Subject: Sunset Area Plan/Placer Ranch Specific Plan
 Draft Environmental Impact Report
 State Clearinghouse No. 2016112012

Letter 15	The California State University, Office of the Chancellor Elvyra F. San Juan, Assistant Vice Chancellor February 21, 2019
----------------------	---

**Re: Sunset Area Plan/Placer Ranch Specific Plan Draft Environmental Impact Report
 (State Clearinghouse No. 2016112012)**

Exhibit 3-6

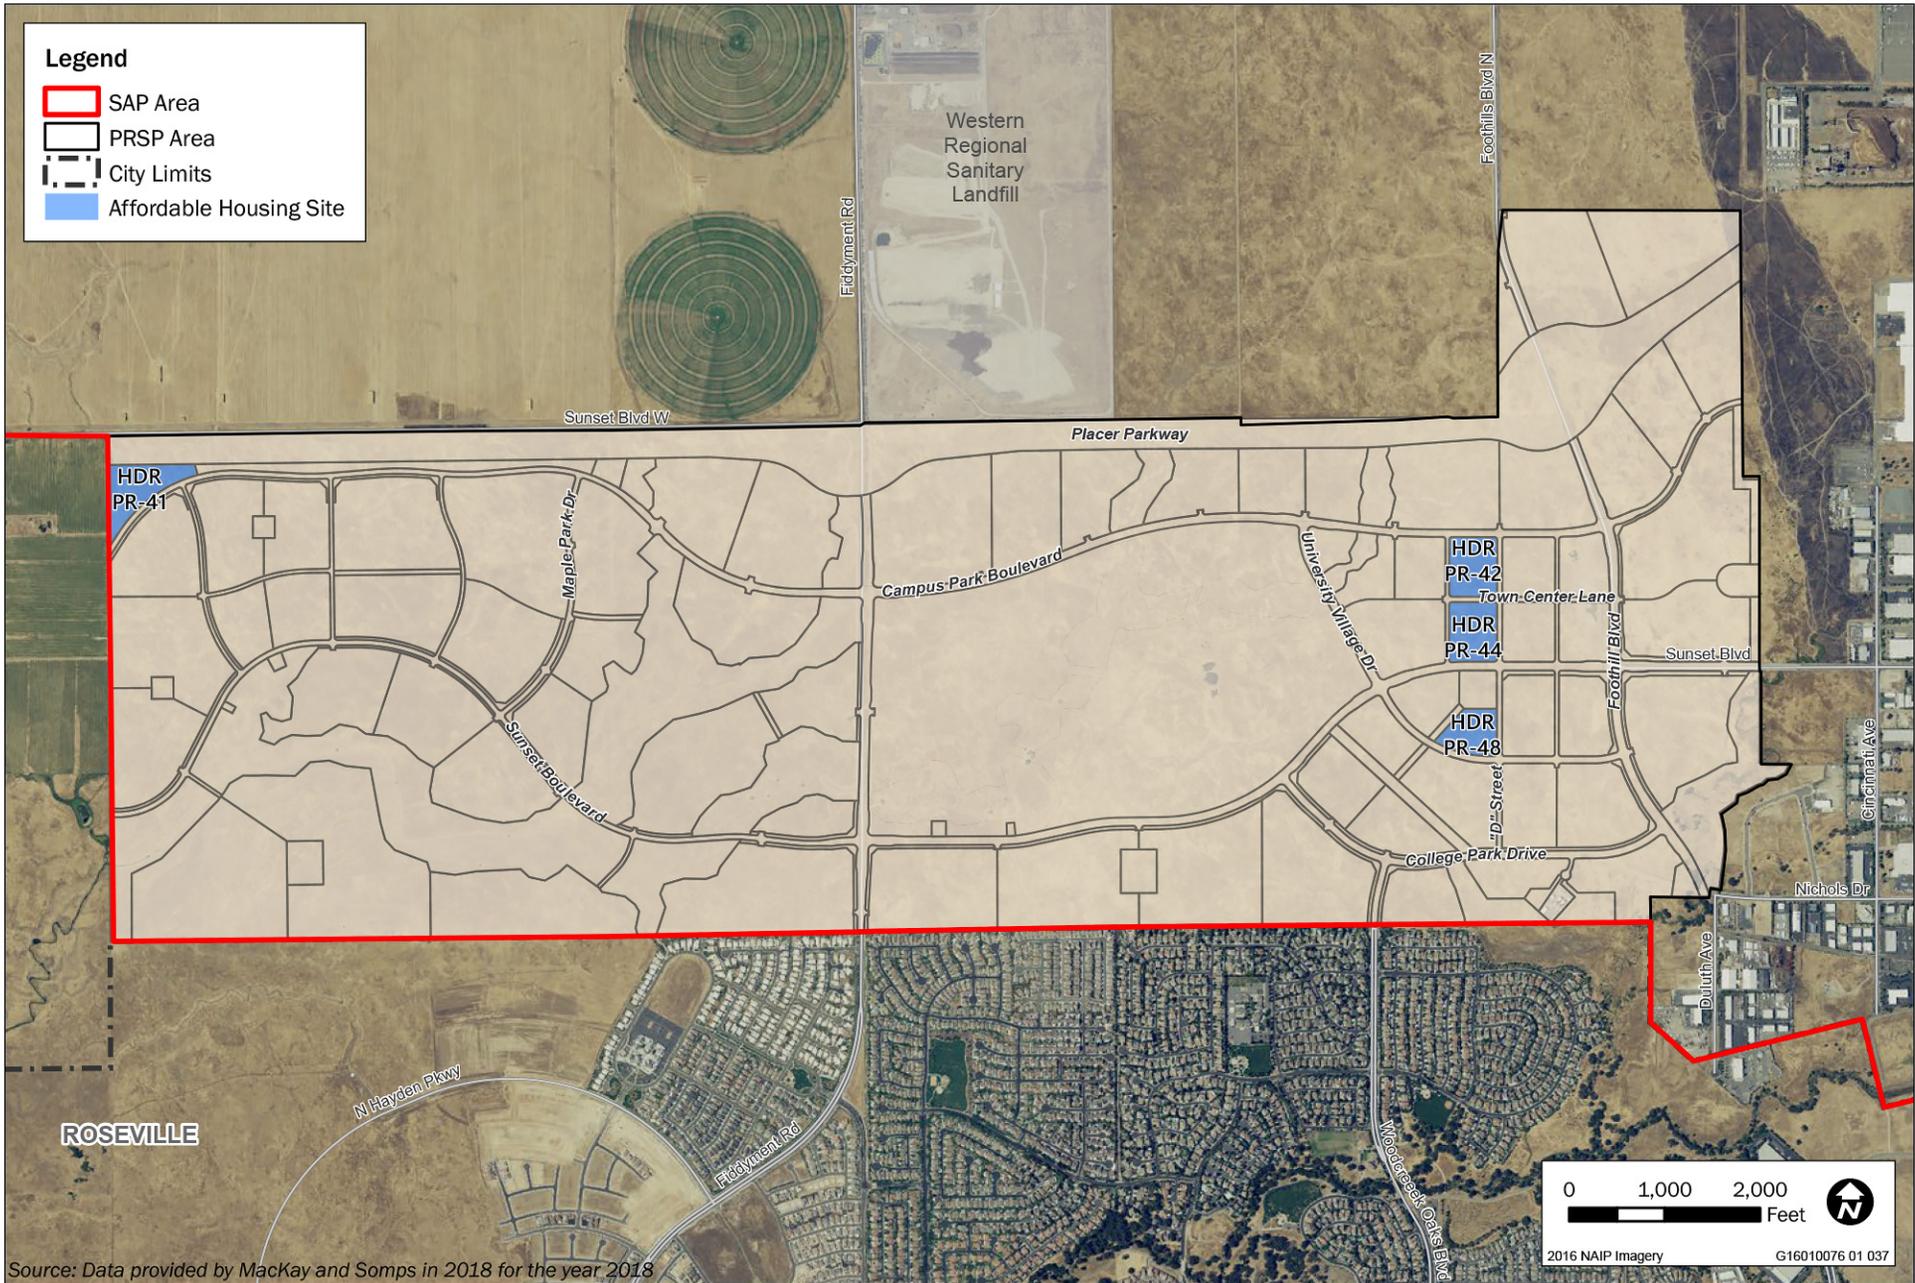
As referenced in the DEIR (p. 4-12-7), the Housing Element requires that the affordable housing be constructed on-site and dispersed throughout the project to the extent possible. The DEIR does not specify the location of the affordable units. In addition, the DEIR should indicate the location of proposed affordable housing in relation to the disposal site (WRSL), flood plains areas, and infrastructure and transit sites. The plan does not identify the location of the infrastructure and transit sites. This information is critical, because the proximity to these sites will play a critical role in determining whether the affordable housing will meet the governmental requirements to qualify for supportive funding, which will determine whether the affordable housing is built and the level of affordability.

- 18-3 The comment requests the EIR identify the anticipated location for affordable housing and suggests the locations of affordable housing in relation to floodplains, public transit, and concentration of affordable housing near the landfill, could affect the project’s ability to qualify for governmental supporting funding. The comment further states that odor impacts related to the reduction of the County’s existing 1-mile buffer for development near the landfill is a significant environmental impact that should be mitigated.

- 18-4 The comment requests the timing for construction of affordable housing be provided. Project-specific timing and triggers identifying affordable housing construction requirements are established in the PRSP Development Agreement and would not inhibit the timing for construction of affordable units, consistent with Housing Element Policy B-6. Exhibit 3-6 shows the locations of affordable housing in the PRSP area.
